July 13, 2010

**Re: Construction Storm Water Inspection at Alum Creek Drive at Groveport Rd. Widening & Traffic S / Franklin County  
Permit Number 4GC03278\*AG**

Figure 1: Storm drain inlet parallel to Groveport Road

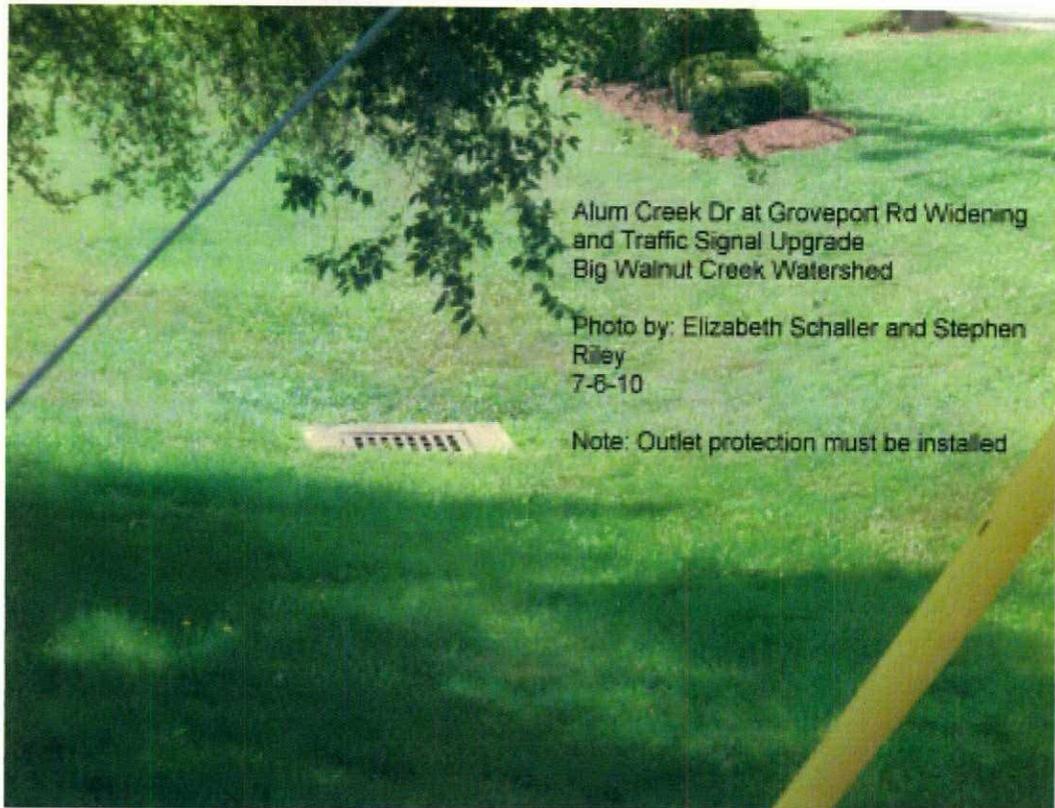
- Sediment and erosion controls are required on the storm drain located east of construction site near Groveport Road (See figure 1).
- Sediment and erosion controls are required on the inlet/outlet leading to the creek running parallel to Alum Creek Drive (See figure 2).
- Sediment and erosion controls are required around any disturbed surface near the creek (See figure 3).
- Please address in your response letter if the appropriate permits have been acquired for the impacts noted to the apparent wetland in photo figure 4.

Figure 3: Disturbed area near creek outlet

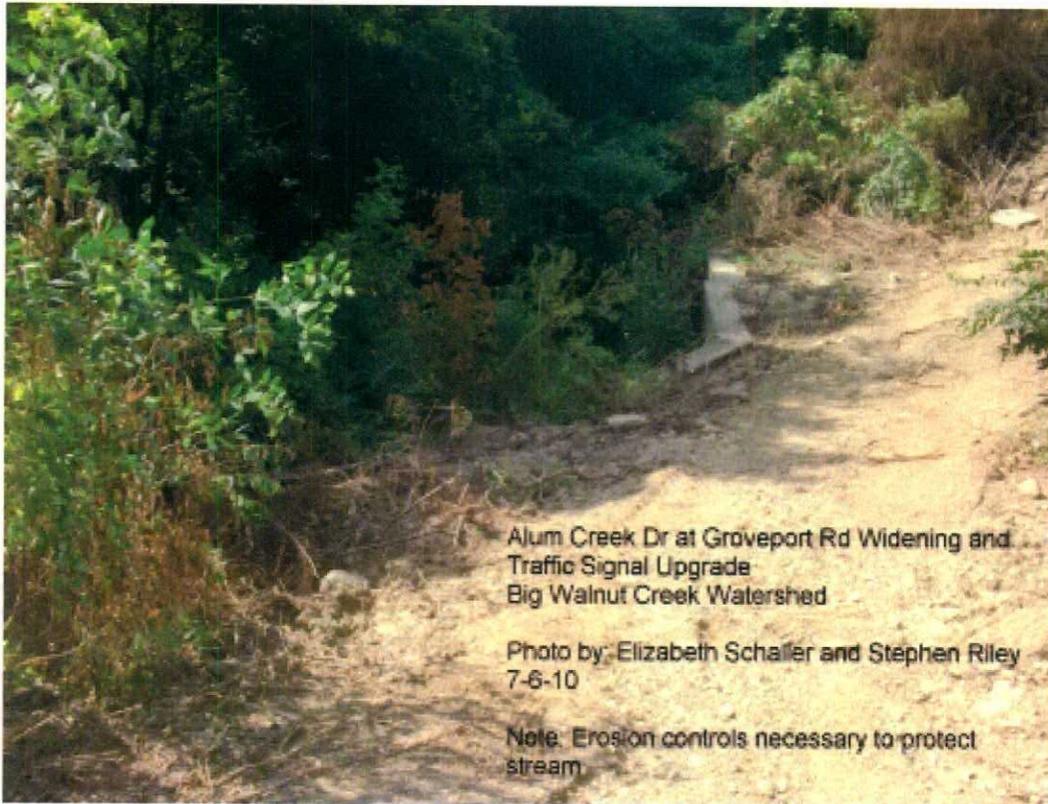
Note: Erosion controls necessary to protect  
stream
